**Subject:** TX SO2 modeling - Martin Lake

**Responses to Significant Comments on the Designation  
Recommendations for the 2010 Sulfur Dioxide National Ambient  
Air Quality Standards (NAAQS) – Supplement for Four Areas in  
Texas Not Addressed in June 30, 2016, Version**

Docket Number EPA–HQ–OAR–2014–0464  
U.S. Environmental Protection Agency

November 29, 2016

**Figure 21. Area excluded by Luminant based on assertion that receptors were within property boundaries or were lake/wetland areas.**

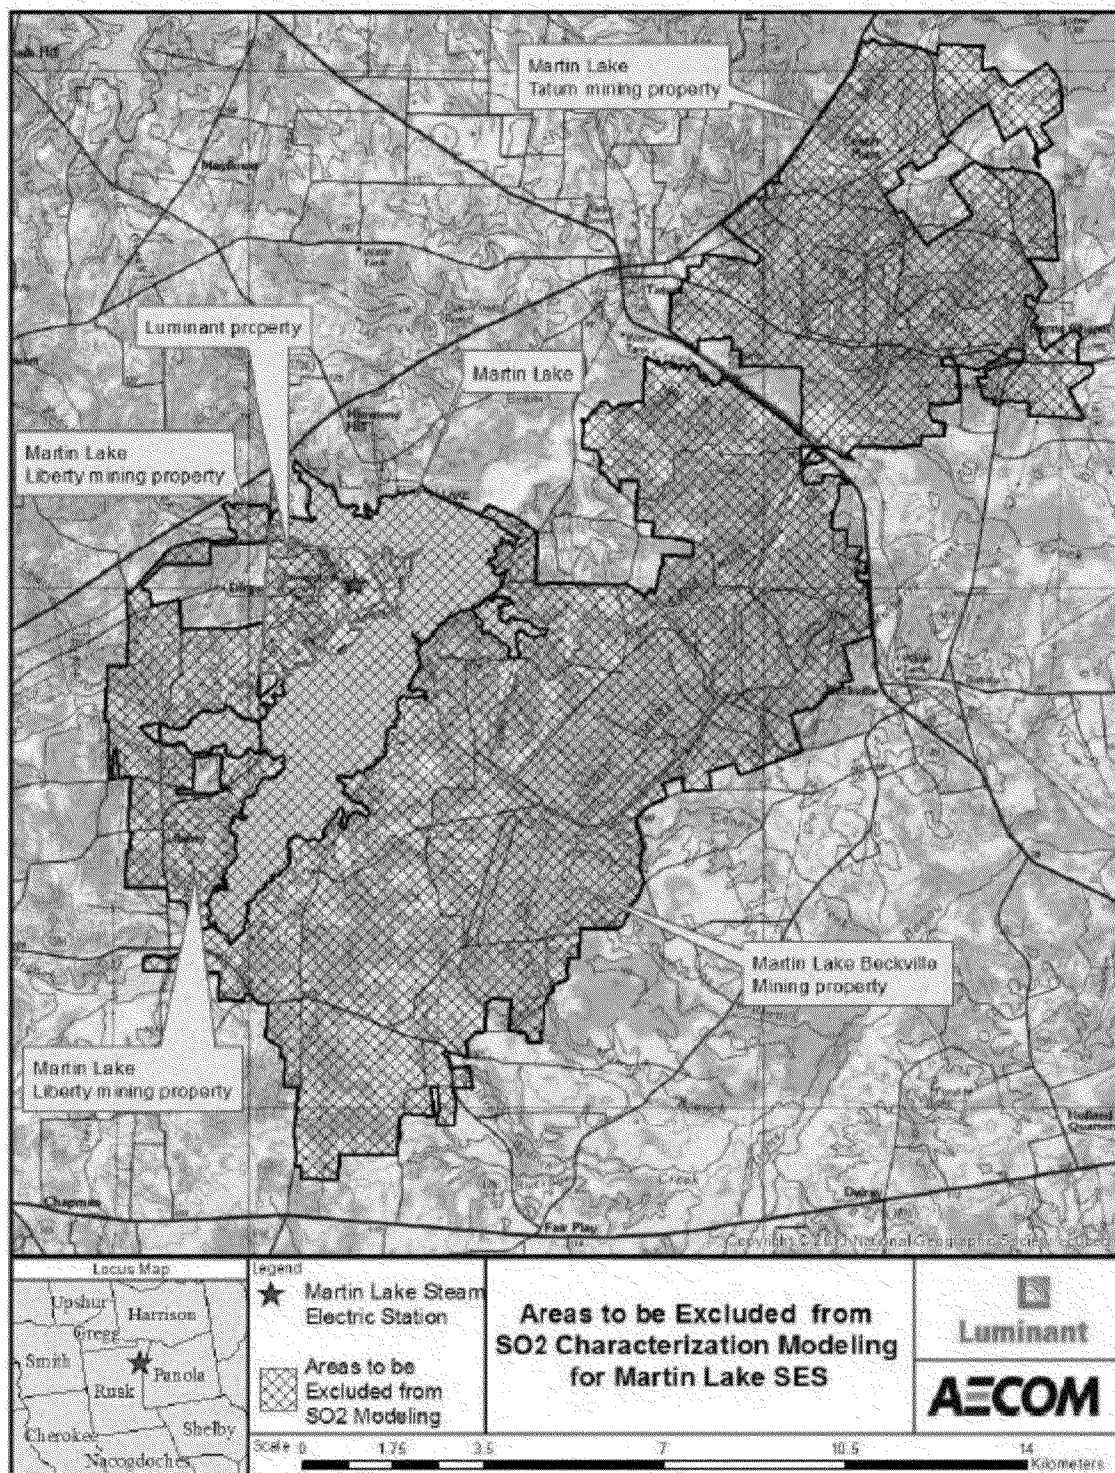
In Figure 21, we have indicated the two areas where the highest values appear in the area Northwest and West of the facility and are in areas not contested by Luminant. Overall, there are several areas with many receptors up to 14% (224 µg/m<sup>3</sup>) above the standard that Luminant does not claim as excluded areas. We do not concur with Luminant that all the areas they excluded in Figure 20 should be excluded, but even if we evaluate just the areas that Luminant does not contest, there are many receptors well above the standard. Figures 22-24 zoom in to where the 2016 Sierra Club modeling results have been overlaid on the Luminant map areas they indicated should be excluded. We note the maximum values in the uncontested area is actually as high as 239.1 µg/m<sup>3</sup>. For our analysis, we conservatively used 224 µg/m<sup>3</sup> to evaluate the modeling but the analysis could also be done based on the 239.1 µg/m<sup>3</sup> value. This would even more clearly demonstrate the area around Monticello is nonattainment.
